Feedback Report

Consultation on revised ATS route structure over the Irish Sea

(Isle of Man and Antrim Sectors of NATS'
Prestwick Centre)

27th January 2017

Figure 5 Proposed route structure post-consultation (note that new waypoint names are draft)

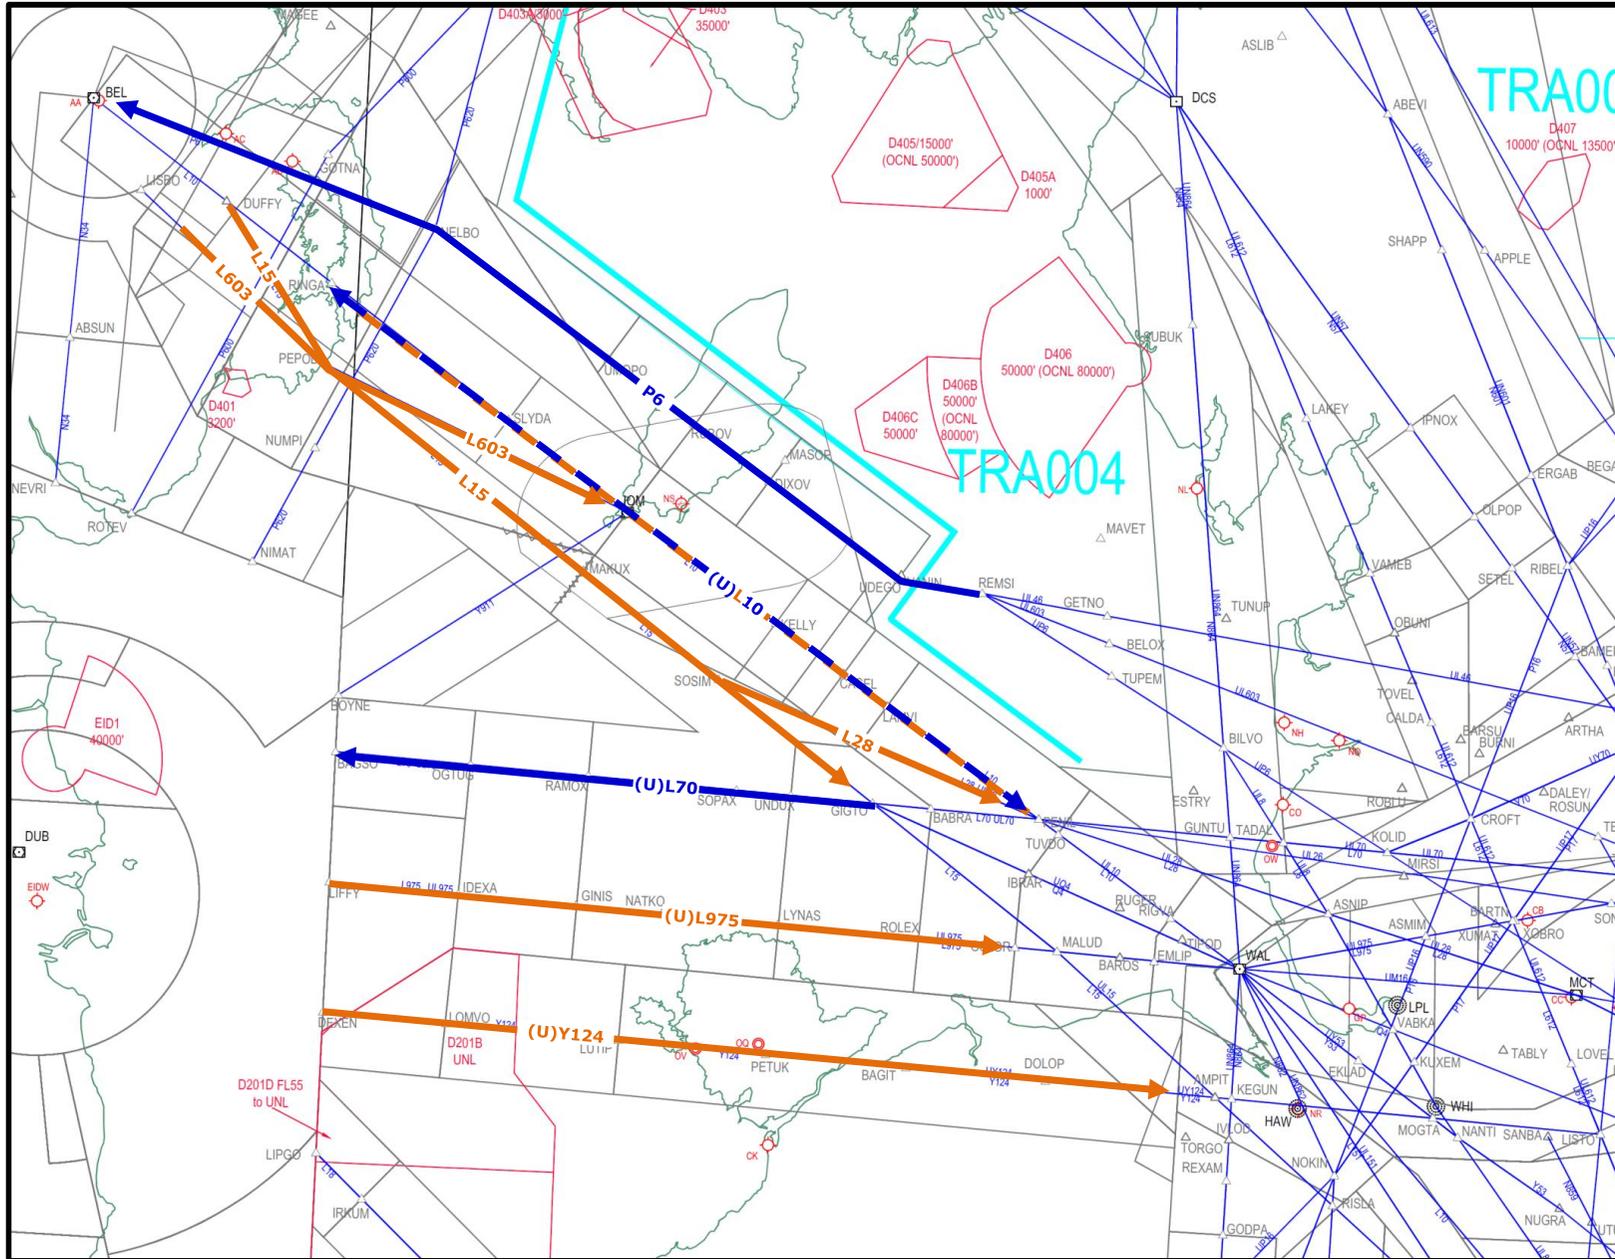
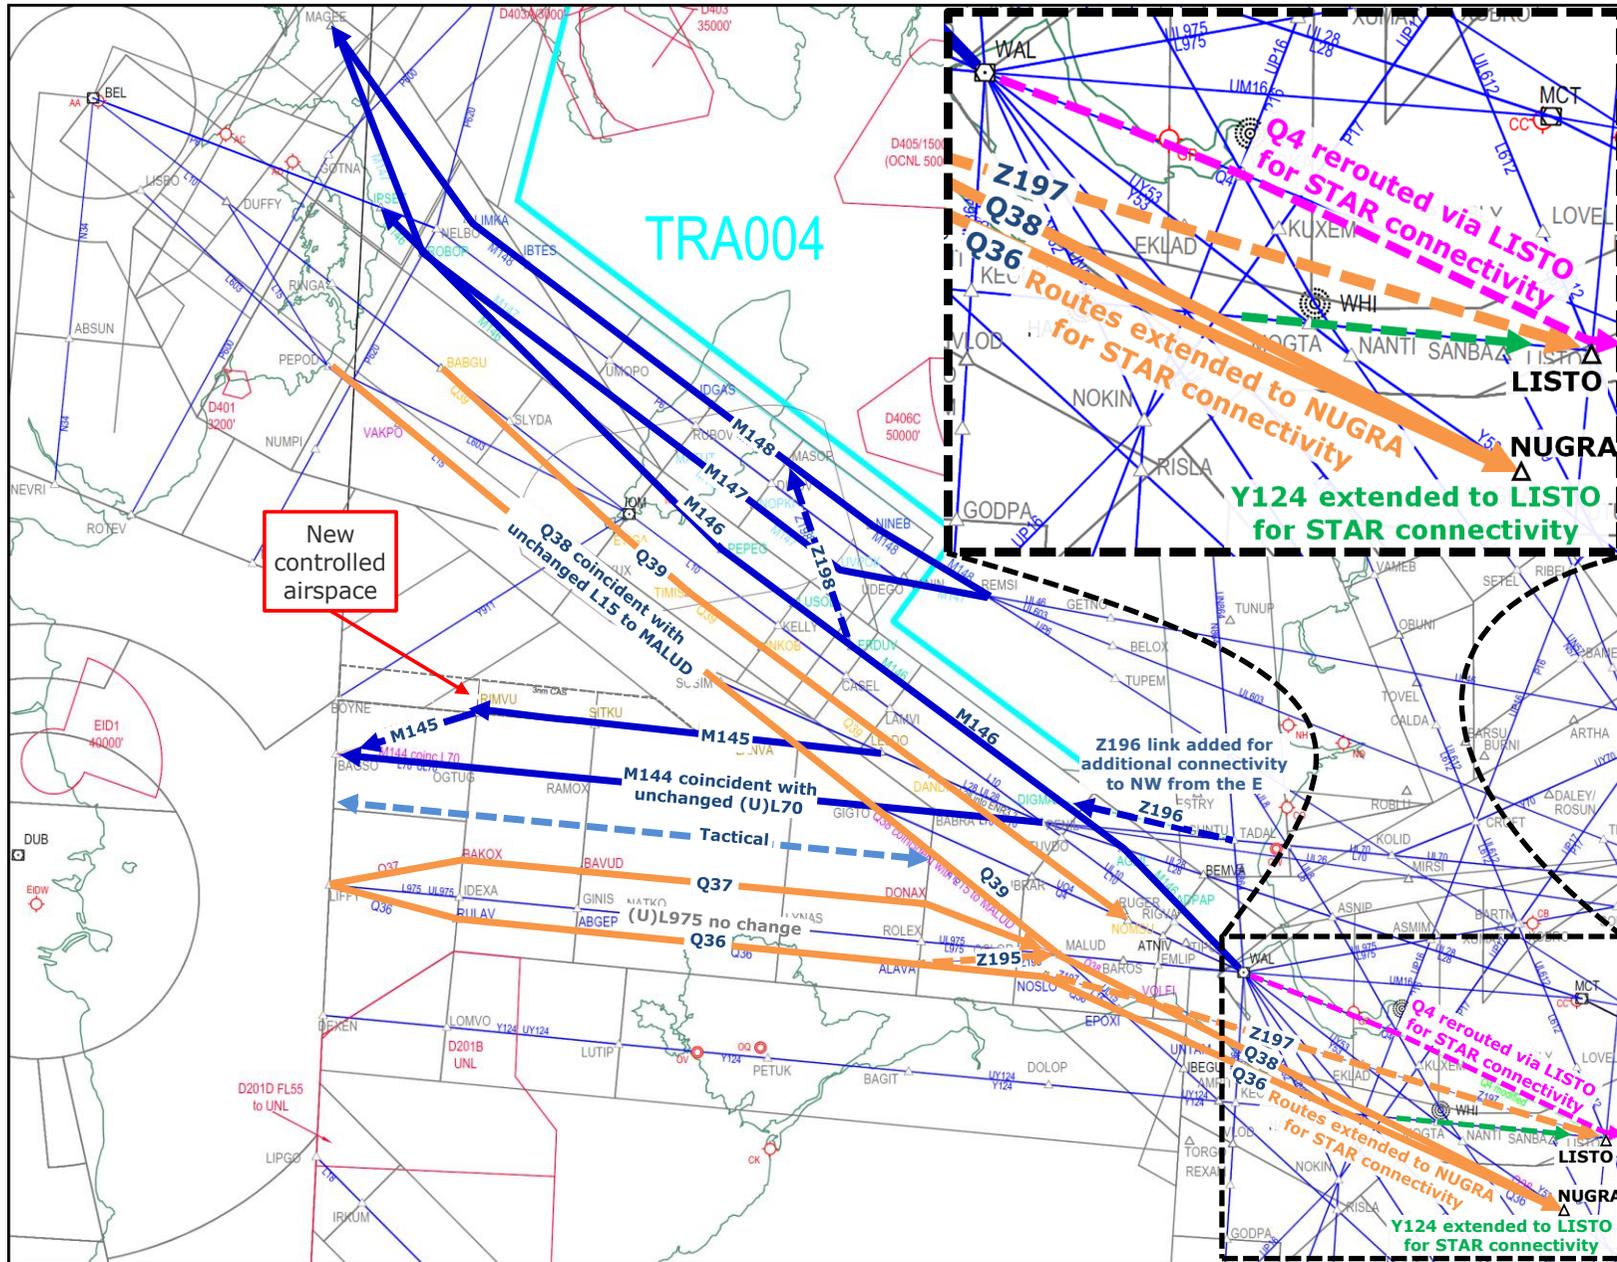
We received feedback concerning some proposed track lengths. We addressed that feedback by adding or extending ATS link routes and by amending some of the details of the route network to minimise track distances, increase route interconnections whilst retaining the desired systemisation.

Compared to the consultation document, the same general arrangement of routes is being progressed, however the feedback received means we are increasing the number of network connections (waypoints) and extending some routes further into the MTMA. Where appropriate the AIP definition of some current ATS routes will be moved from ENR3.1 (Lower ATS Routes) and ENR3.2 (Upper ATS Routes), to ENR3.3 (RNAV routes).

The current RNAV5 route structure can be compared with the proposed RNAV1/RNAV5 route design – see Figure 4 and Figure 5 on pages 12 and 13 respectively.

Figure 7 Proposed airspace arrangements up to FL195

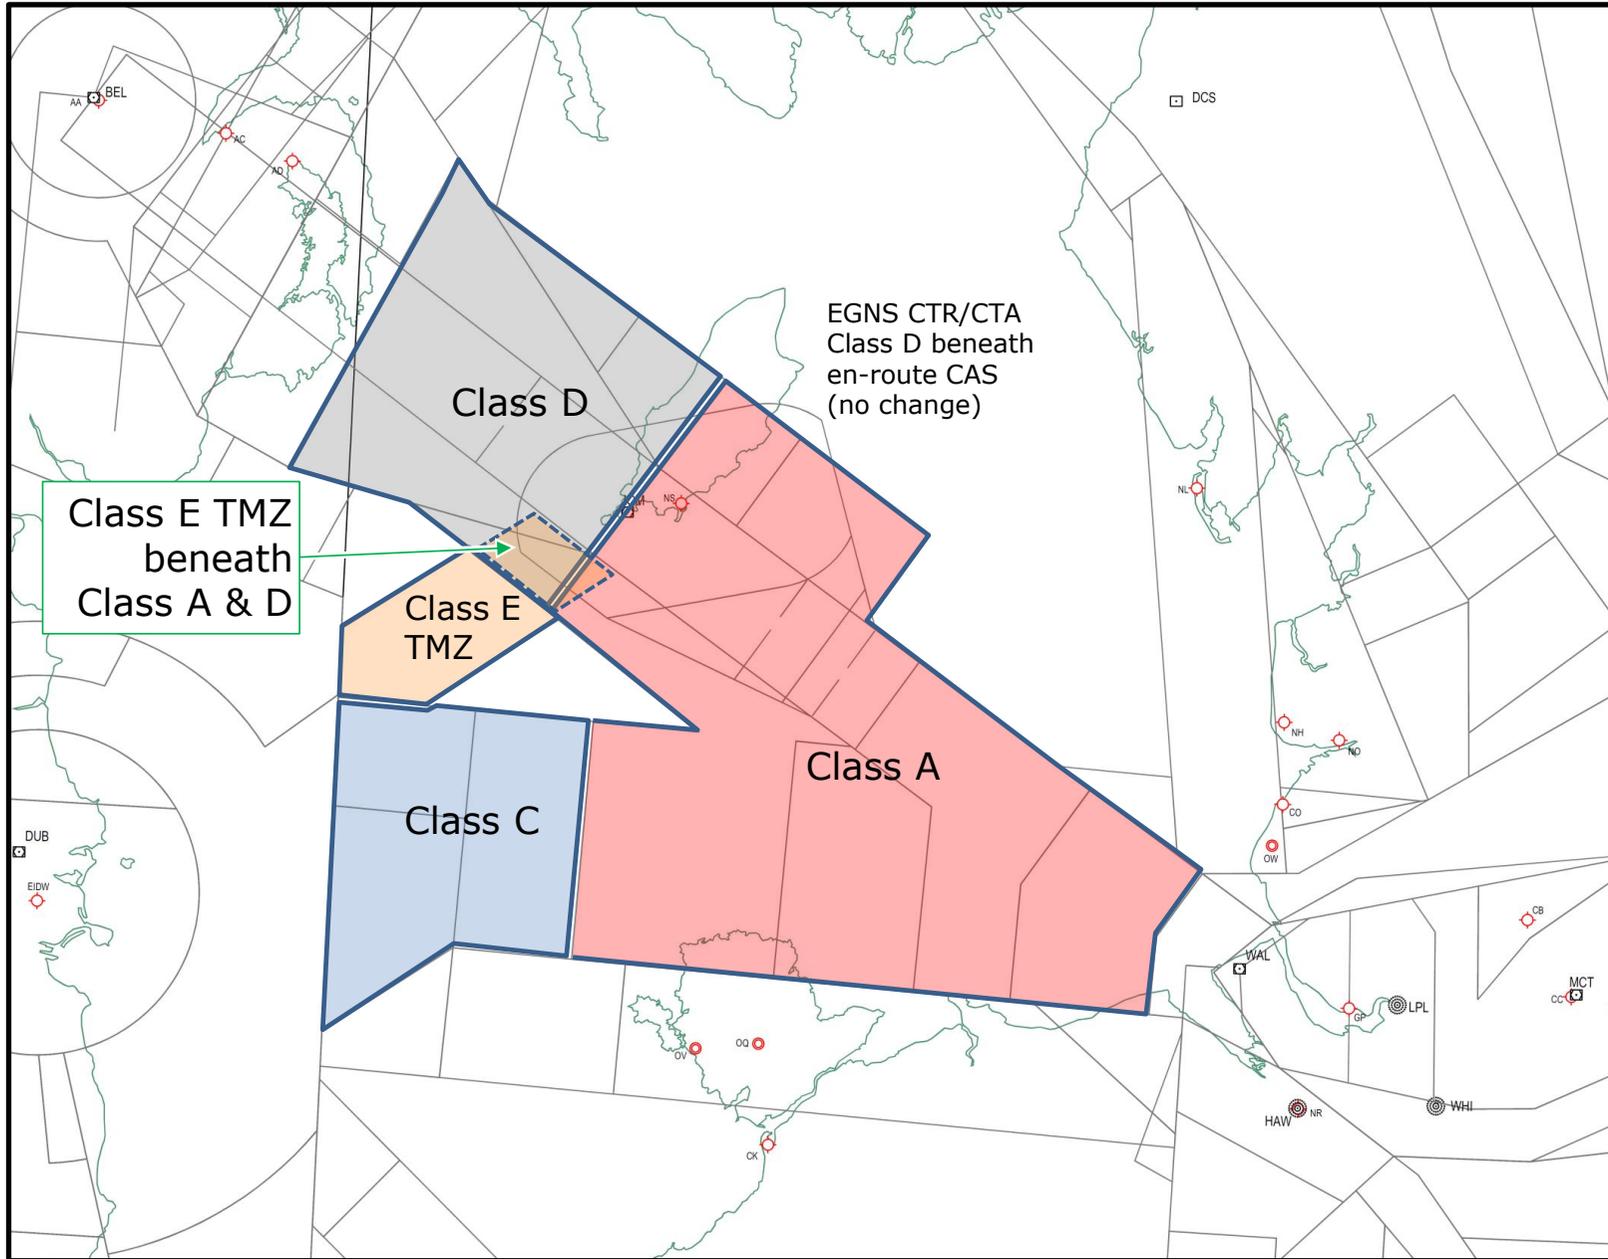
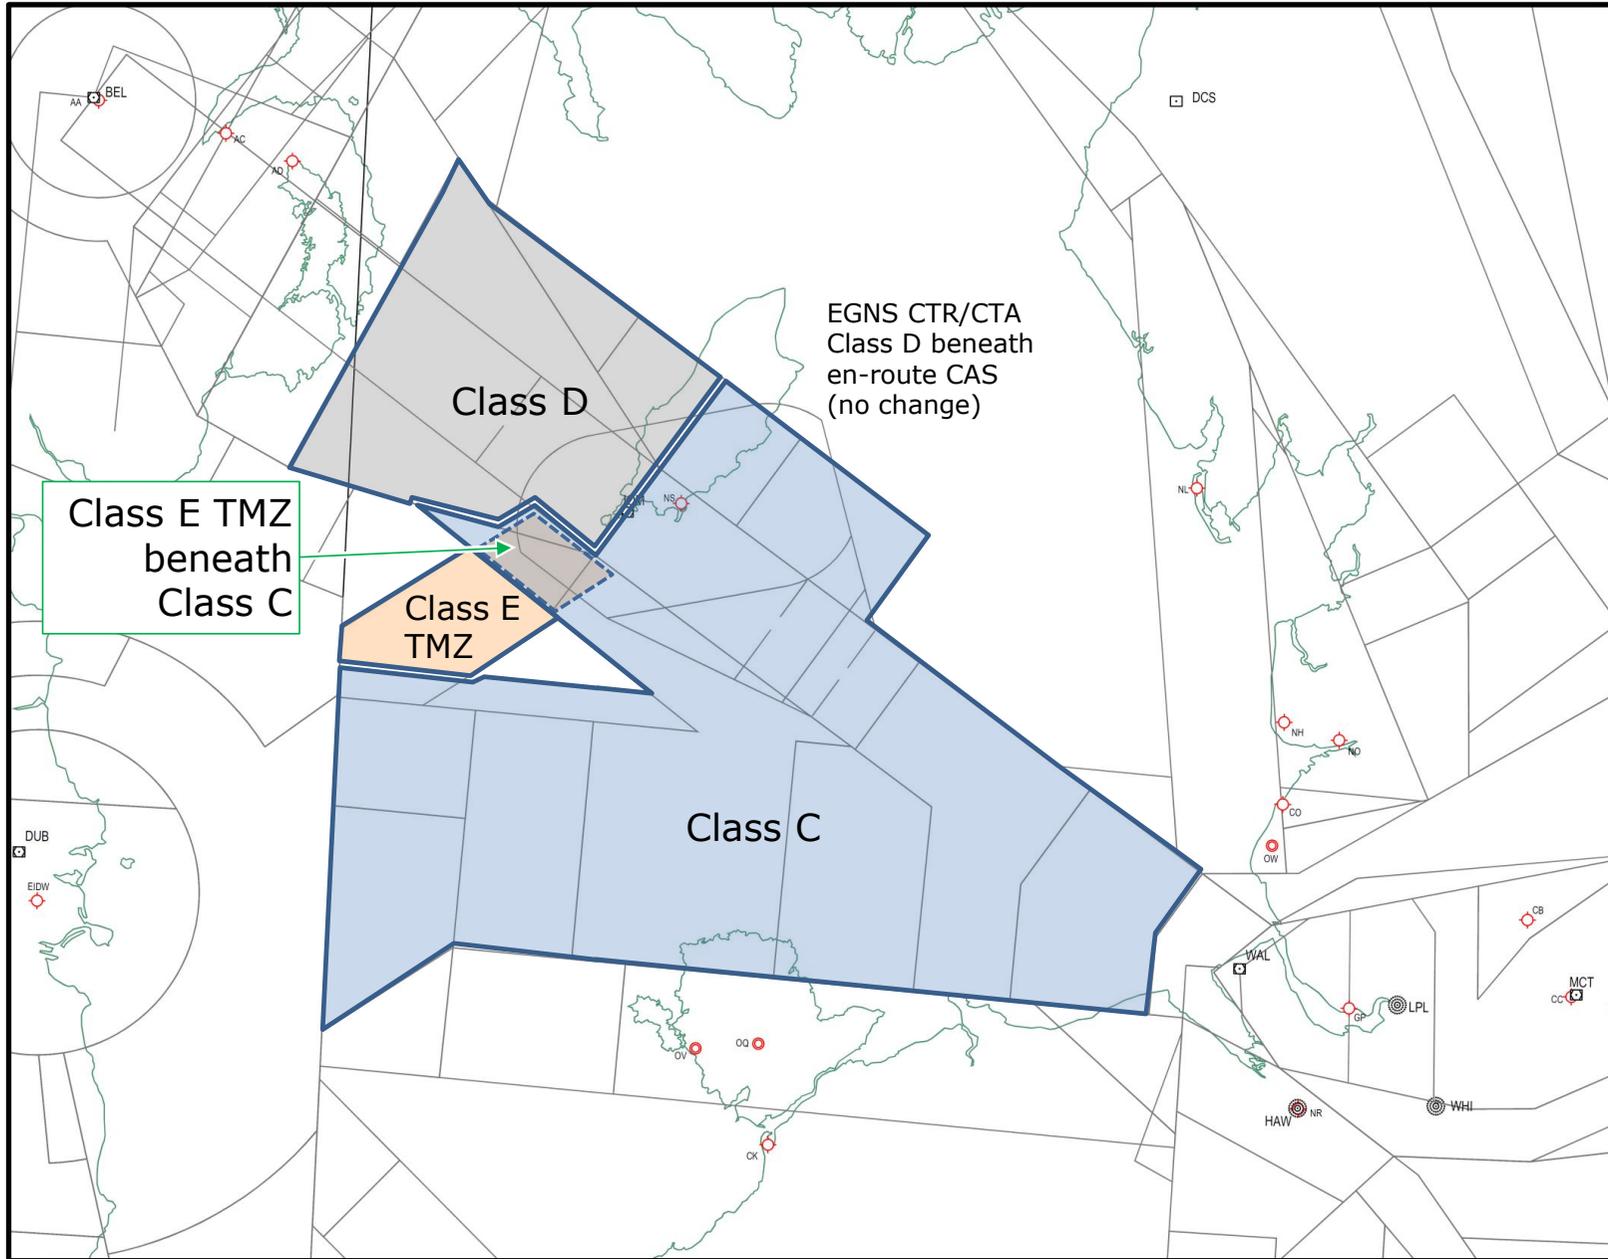
In the vicinity of southern Strangford CTA1, western L15 and Y911 there is a complex of Classes A, D, E and TMZ from FL75-FL195. We intend to simplify this area, please see paragraph 5.2 in the next section. Also see paragraph 4.3 above, regarding Isle of Man Ronaldsway Airport's proposed airspace change.

We also intend to reduce airspace complexity in the region by changing two small portions of existing Class D to Class C and one small portion from Class D to Class E TMZ (see Figure 7 on page 15). These changes would all be from FL75 and above, and would involve a change to Strangford CTA1's southern boundary.

We believe that the aviation impacts of this would be small. VFR flights could continue to access Class C areas with the same clearance they would get in Class D, or without any clearance at all if entering Class E provided they observe the TMZ. Y911's Class E TMZ would be retained beneath the proposed larger Class C volume, and would be more easily identifiable on VFR charts. We believe the VFR chart simplification in this area is sufficient justification to change these three small volumes, when compared with today and the original consultation material. Chart simplification means the likelihood of accidental infringement would be lower, increasing overall safety in the region.

Figure 8 Manchester STAR revisions

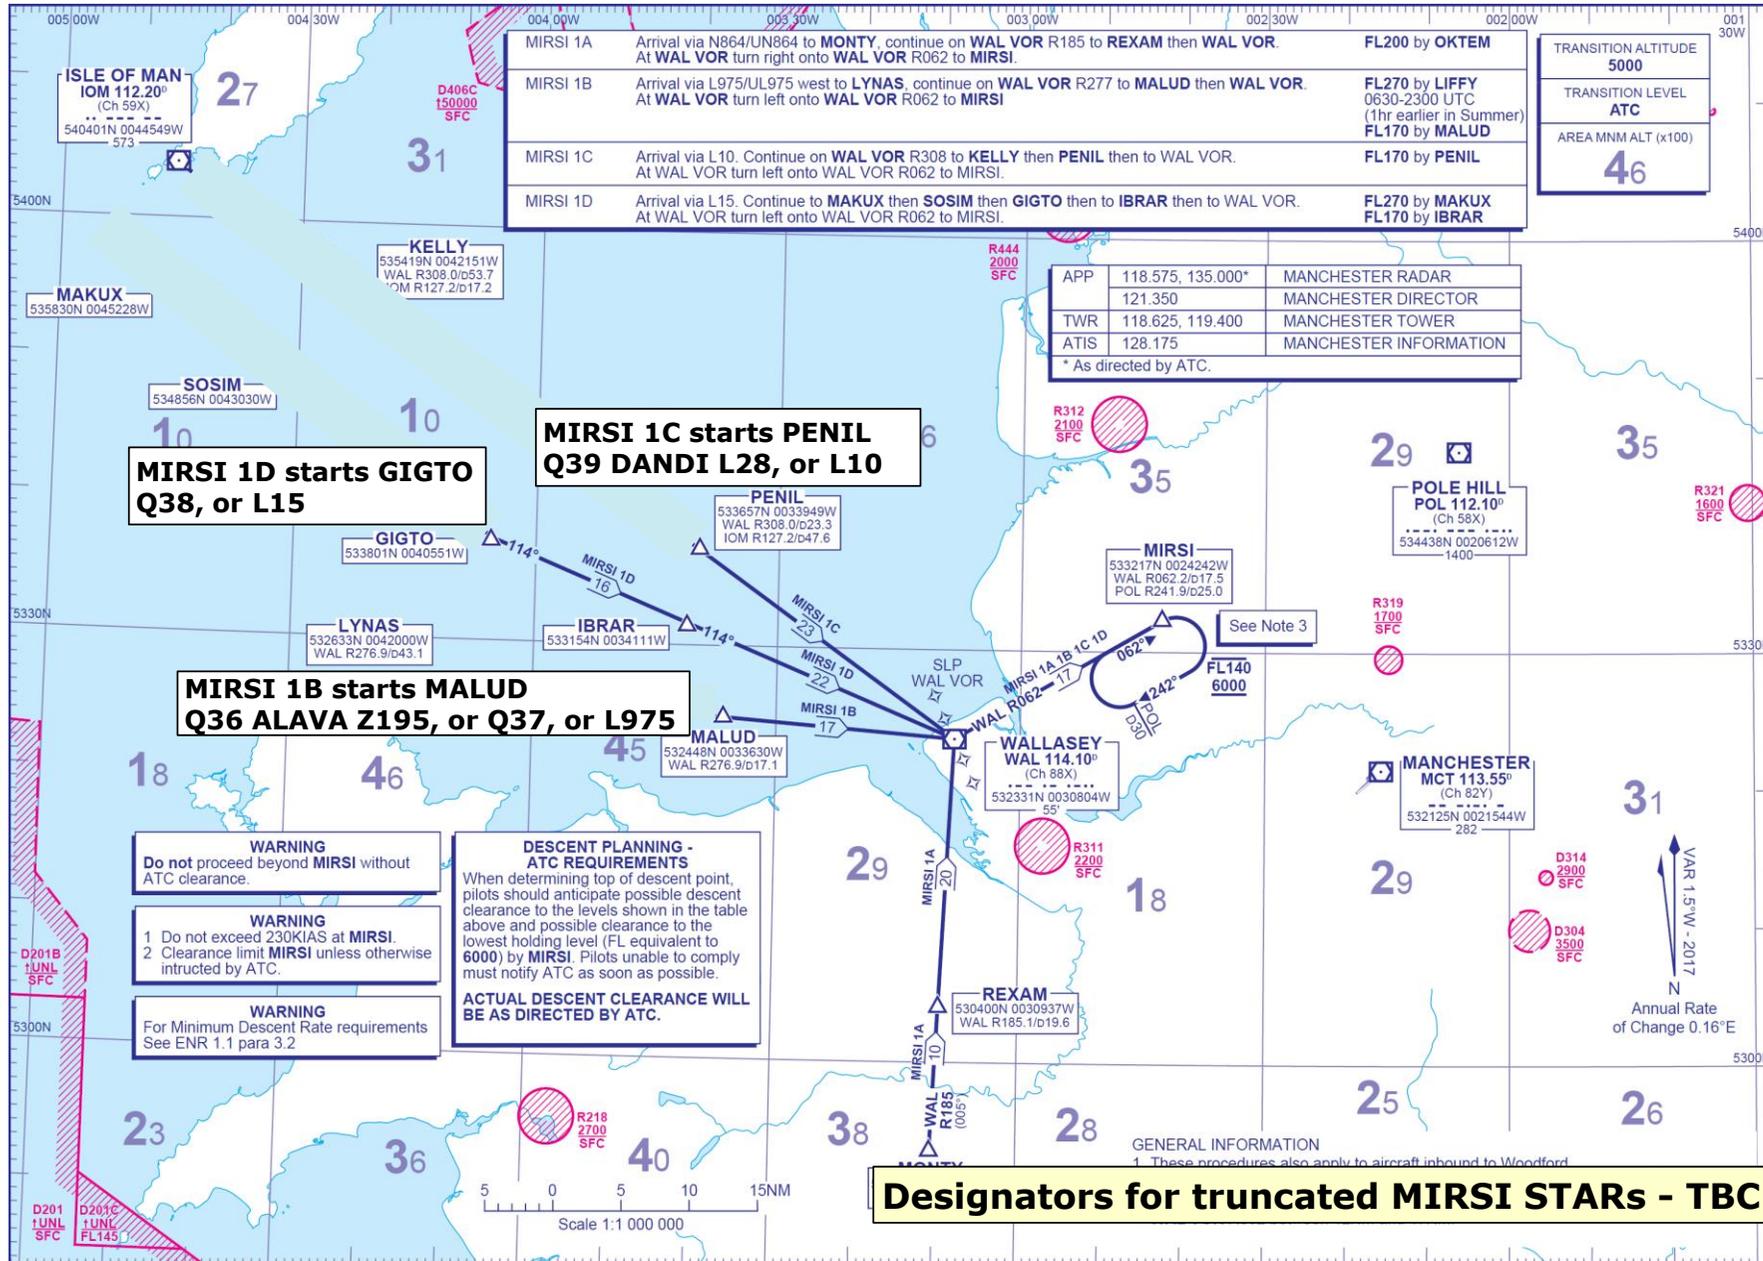
Appendix B of the consultation document illustrated how STARs into Manchester and Liverpool Airports would be truncated under this proposal. These will be progressed.

As previously discussed, some routes and network links will be updated following feedback received. The consulted-upon truncations will be suitably modified to ensure appropriate connectivity is retained. The arrival route options available under this proposal mean that several other STAR charts will also be amended, some in an editorial manner.
